C2M comment discussion

IEEE 802.3ck Chief Editor

IEEE P802.3ck Task Force

April 29, 2020

Figure 120G-2—100GAUI-1 C2M insertion loss budget at 25.56 GHz

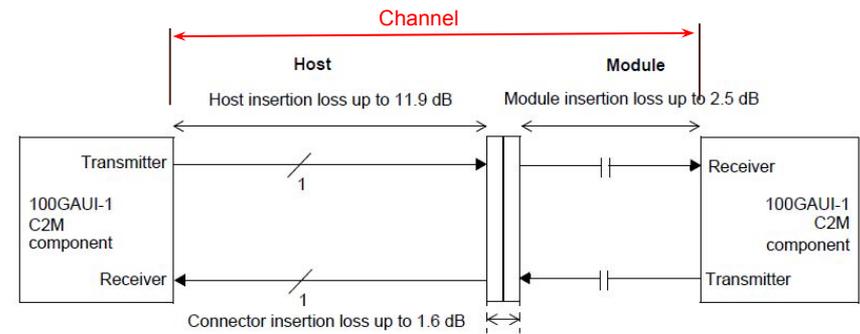
CI 120G	SC 120G.1	P 218	L 48	# 72
Mellitz, Richard		Samtec		
Comment Type	TR	Comment Status	D

The equation is only recommended. The way 120G-1 is annotated before the graph is annotated suggest that that it is required for performance.

Add section titled 120G.1.2 Informative COM based on sun_3ck_01a_0120.pdf slide 29 and 30

CI 120G	SC 120G.1	P 218	L 48	# 71
Mellitz, Richard		Samtec		
Comment Type	TR	Comment Status	D

The equation is only recommended. The way 120G-1 is annotated before the graph is annotated suggest that that it is required for performance.

Add section titled 120G.1.1 Informative IL

PROPOSED REJECT.

Contrary to the comment, the suggested remedy is proposing to add an additional informative constraint on the channel using COM with reference to a previously reviewed presentation.

PROPOSED ACCEPT IN PRINCIPLE.

Equation 120G-1 is introduced in previous paragraphs as follows:

"The recommended insertion loss budget is characterized by Equation (120G-1) and illustrated in Figure 120G-5."

The Figure with the graph of the equation has the following title:
"Figure 120G-5-Recommended channel insertion loss"

The related text clarifies that the equation is a recommended specification.

However, it would be beneficial to package up the channel specification in a channel subclause similar to 120F.4 "Channel characteristics".

Move the informative channel specifications to a new subclause "120G.4 Channel characteristics".

Comment #72

Assuming that intent is to add an informative COM specification for the channel from host device output to module device input.

New proposed response to Comment #71:

For the 100GAUI-1 and 200GAUI-2 descriptions, Equation 120G-1 is introduced as follows: "The supported insertion loss budget is characterized by Equation (120G-1) and illustrated in Figure 120G-5."

For the 400GAUI-4 description, Equation 120G-1 is introduced as follows: "The recommended insertion loss budget is characterized by Equation (120G-1) and illustrated in Figure 120G-5."

Change: "The supported insertion loss budget"

To: "The recommended insertion loss budget"

As the comment recommends, it would be beneficial to package up the channel specification in a channel subclause similar to 120F.4 "Channel characteristics".

Move the informative channel specifications to a new subclause "120G.4 Channel characteristics".
